Type of Submission: Notice of Intent	Type of Action: Plug and Abandonment
Date Sundry Submitted: 05/24/2022	Time Sundry Submitted: 01:19
Date proposed operation will begin: 05/24/2022

Plug and Abandonment Procedure
for
DJR Operating, LLC
Jicarilla A 156 4
API # 30-039-82311
SE/NW, Unit F, Sec. 1, T23N, R2W
Rio Arriba County, NM

Attachment to notice of Intention to Abandon

Well: Jicarilla A 4

Proposed Wellbore Diagram
DJR Operating, LLC
Jicarilla A 156 4
API # 30-039-82311
SE/NW, Unit F, Sec 1, T23N, R2W
Rio Arriba County, New Mexico

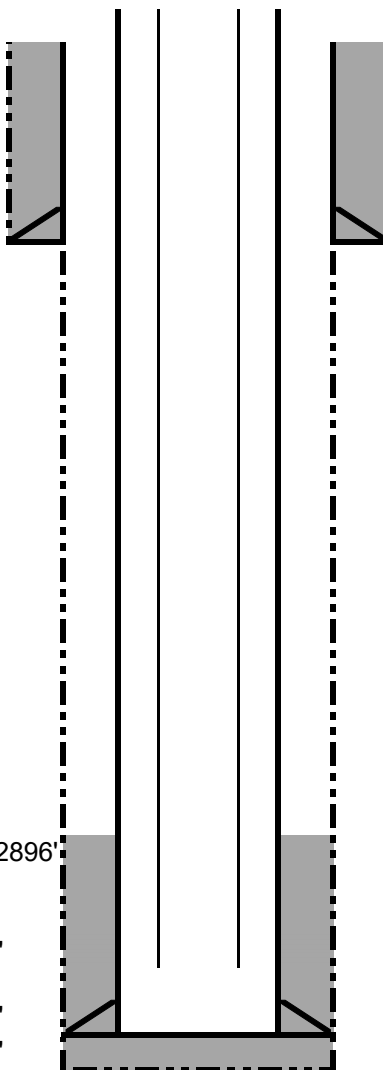
1. Plugging operations authorized are subject to the attached "General Requirements for Permanent Abandonment of Wells on Federal and Indian Lease."
2. The following modifications to your plugging program are to be made:
 - a) Extend Plug 2 from perfs at 3030' to a TOC of 2560' to account for the BLM Kirtland top and required excess.
 - b) Extend Plug 3 from perfs at 1600' to a TOC of 1450' to account for the BLM Nacimiento top and required excess.
3. Farmington Office is to be notified at least 24 hours before the plugging operations commence (505) 564-7750.

Extend Plug 2 from perfs at 3030' to a TOC of 2560' to account for the BLM Kirtland top and required excess.

Extend Plug 3 from perfs at 1600' to a TOC of 1450' to account for the BLM Nacimiento top and required excess.

Plug 4: Surface shoe and surface plug: Perf holes at 146'. Tie onto 4-1/2" casing and mix and pump sufficient cement to bring TOC to surface, inside and outside.

Plug 3: Nacimiento top: Perf holes at 1752'. Set CR at 1702'. Sqz below CR with sufficient cement to bring TOC to 1652', inside and outside.

Plug 2: Kirtland, and Ojo Alamo tops: Perf holes at 2870'. Set CR near 2820'. Mix and pump sufficient volume to bring TOC to 2614', inside and outside.

Plug 1: Pictured Cliffs and Fruitland tops: Set CR near 3100'. Sqz below CR with 10 sx. Spot plug above CR to bring TOC to 2922'. Run CBL.
